## Determination 2017/061

# Regarding the proposed demolition of half of a duplex building at 74 Spencer Street, Auckland and the compliance in respect of the remaining half at 76 Spencer Street, Auckland

**Figure 2: Building outline based on the consented structural drawings**

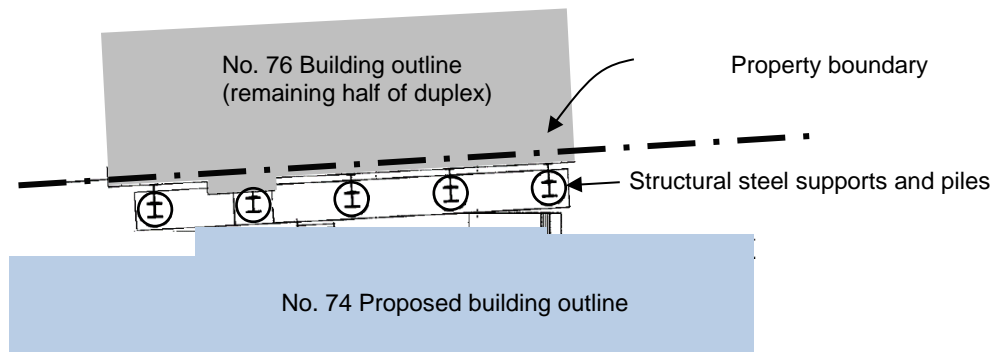
- 5.3.4 The expert reviewed the architectural and structural drawings, and noted that there was contradictory and missing information from both:
- Architectural drawings propose timber pole retaining walls adjacent to the boundary with No. 76; however, this is in conflict with the proposed support structure to the party wall (see Figures 2 and 3).

- The structural drawings propose piles for the support structure in a location that will conflict with the location of the timber retaining walls.
  - Excavation for the retaining walls as consented will undermine the party wall foundations and underpinning will be required; the underpinning work is not shown.

- There is a lack of documentation for the design and detailing of the timber pole retaining walls.
  - The excavations for the party wall support structure are proposed immediately adjacent to the remaining half of the duplex, which contradicts the assumptions of the second report (see Figures 2 and 3).

- 5.3.5 The expert also identified that the consented building work contradicted the second report. The second report qualified its findings on an understanding that no excavation was proposed immediately adjacent to the remaining half of the duplex; however, the consented drawings clearly show earthworks within a metre to the boundary and immediately adjacent the party wall support structure.

- 5.4.1 The expert stated that careful consideration of the conflicting drawings will need to be carried out regarding the interaction between underpinning the existing party wall foundation, construction and excavation for the timber pole retaining walls, and the piles for the support structure to the party wall.
- 5.4.2 The expert observed that excavation on the boundary adjoining the common party wall should have been referred back to the author of the second report for their comment and recommendations.
- 5.4.3 The expert concluded that there was insufficient and inadequate information in the building consent documentation to demonstrate compliance with Clause B1 in relation to the underpinning and support of the party wall between No. 74 and No. 76 including the adjoining proposed retaining walls.
